REQUEST

Current Zoning: MUDD-O (mixed use development district, optional) Proposed Zoning: MUDD-O SPA (mixed use development district, optional, site plan amendment) with five-year vesting rights

Approximately 23.38 acres located on the north side of West Tyvola Road, south of Yorkmont Road. (Council District 3 - Mayfield)

PLANNING STAFF REVIEW

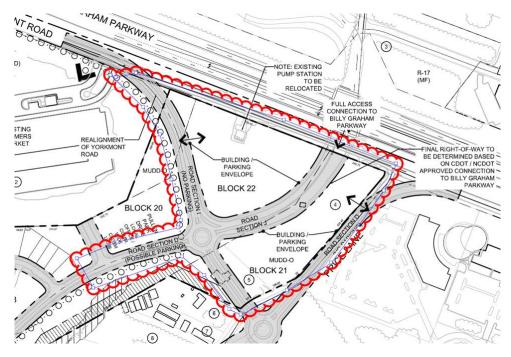
- 4. After evaluating the changes proposed in this site plan amendment and the effect it has on existing and future transportation infrastructure, CDOT requests the petitioner revise the site plan to commit to the following before the next request for certificate of occupancy:
 - a. the construction of Hive Drive connecting to City Park Drive and Millennium Avenue as part of the townhome development proposed in the site plan amendment.
 - b. dedication of right-of-way, fee simple, for the future connection of Speer Boulevard to Billy Graham Pkwy, the realignment of Yorkmont Road to connect to the future Speer Boulevard and Price Lane as part of the townhome development proposed in the site plan amendment. The right-of-way location should be shown on the plan as depicted in the approved 2007-082 rezoning shown below.
